Verification of the Acceptability of a 1-Pin Burnup Limit of 60 MWD/kgU for Combustion Engineering 16x16 PWR Fuel

Generic Approval of Topical Report CEN-386-P
"Verification of the Acceptability of a 1-Pin Burnup
Limit of 60 MWD/kgU for Combustion Engineering
16x16 PWR Fuel"

SUBJECT: GENERIC APPROVAL OF C-E TOPICAL REPORT CEN-386-P, "VERIFICATION
OF THE ACCEPTABILITY OF A 1-PIN BURNUP LIMIT OF 60 MWD/kg FOR
COMBUSTION ENGINEERING 16X16 PWR FUEL (TAC NO. M82192)

Fig. 1. ANO-2 Oxide Data

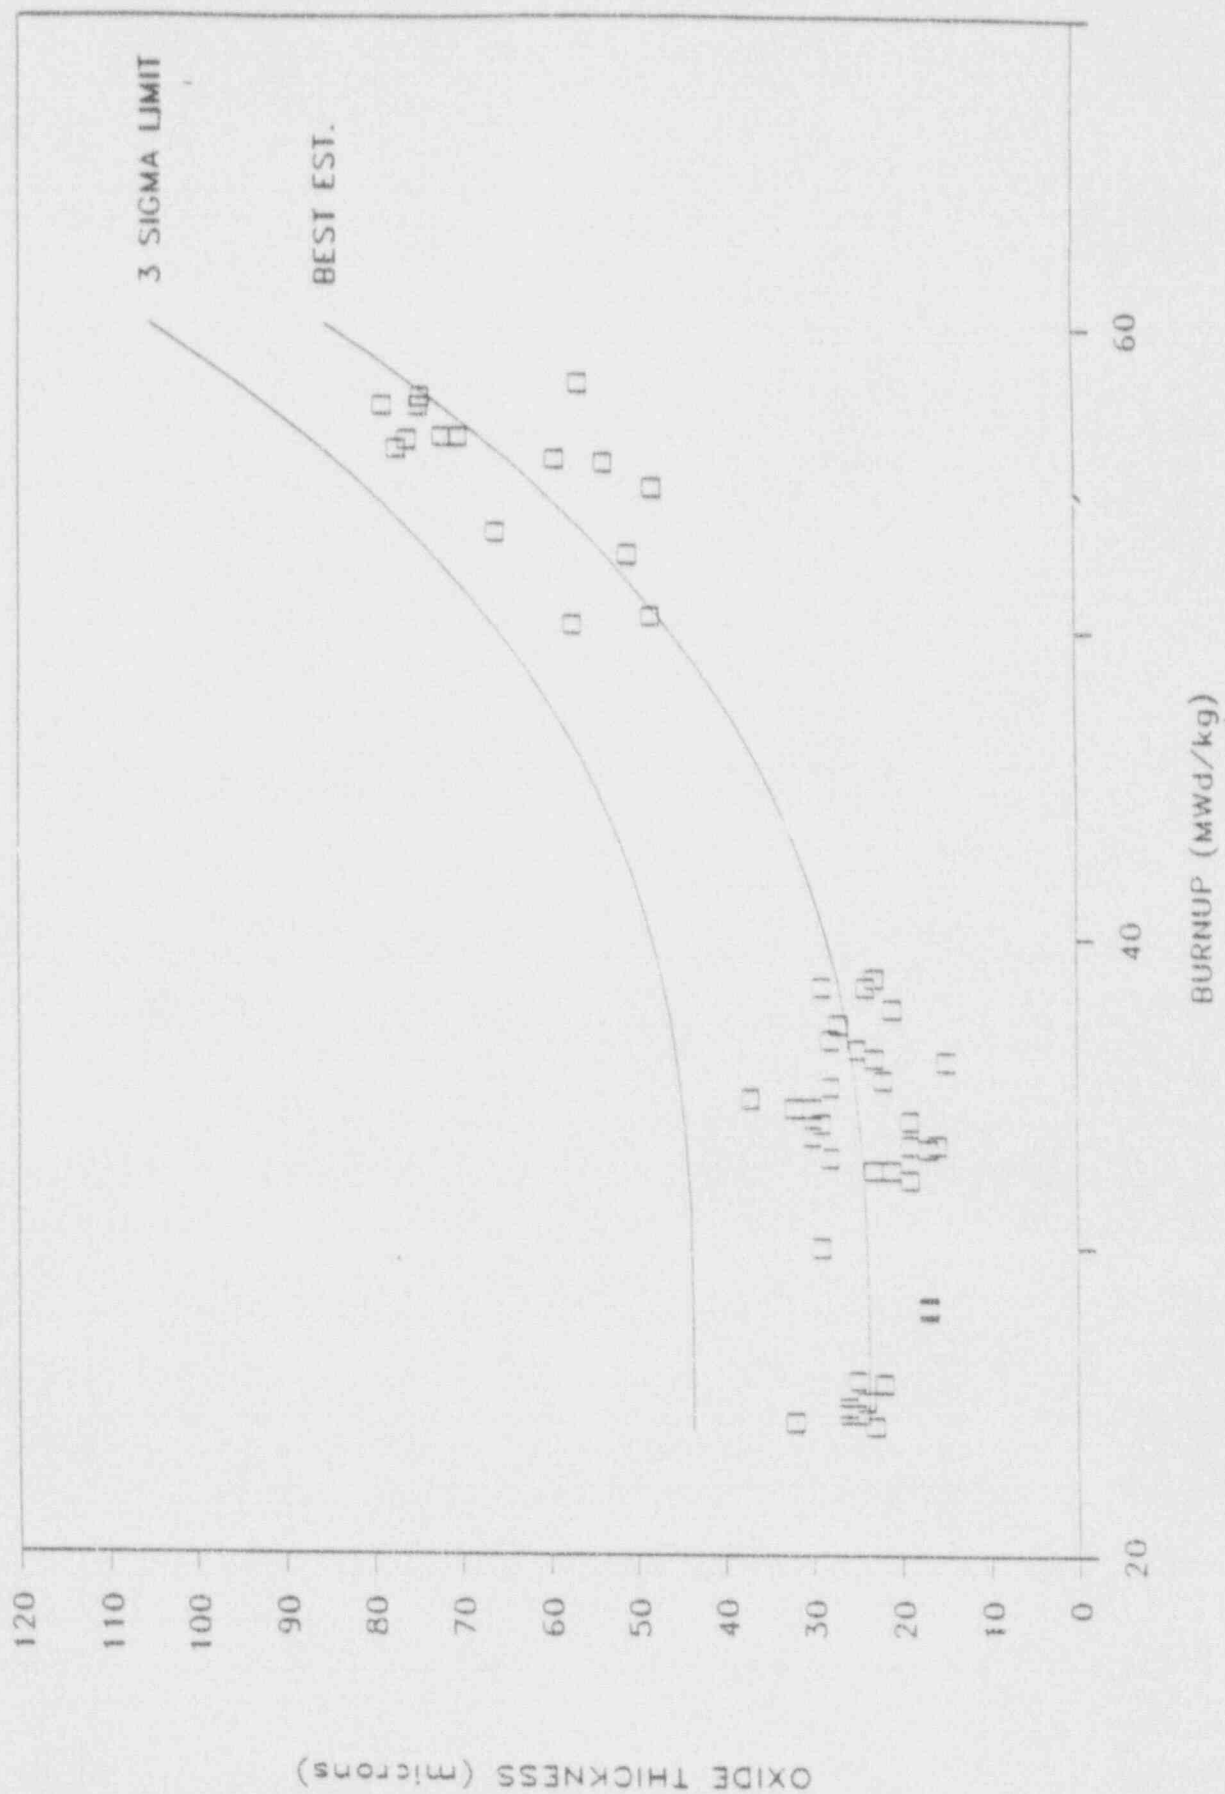
Question #1:

The Calvert Cliffs and Fort Calhoun data are shown in Figure 4.1.2.a-1 in the report for information. They were not included in the curve fit. The curve fit and the standard deviation were determined from just the ANO-2 fuel rod data. This is shown in the attached Figure 1, which plots the data, the curve fit, and the 3σ limit. Figure 1 shows that the 3σ line is a conservative bound to the ANO-2 fuel rod data and that the standard deviation for these data is not burnup dependent. As mentioned above, Figure 4.1.2.a-1 includes data from reactors other than ANO-2. Consequently, the spread noted in that figure reflects the influence of a variety of plant specific factors and not just burnup alone. These factors include differences in the fuel rod operating history (e.g., heat flux), coolant temperature, and the temperature at the oxide/metal interface.
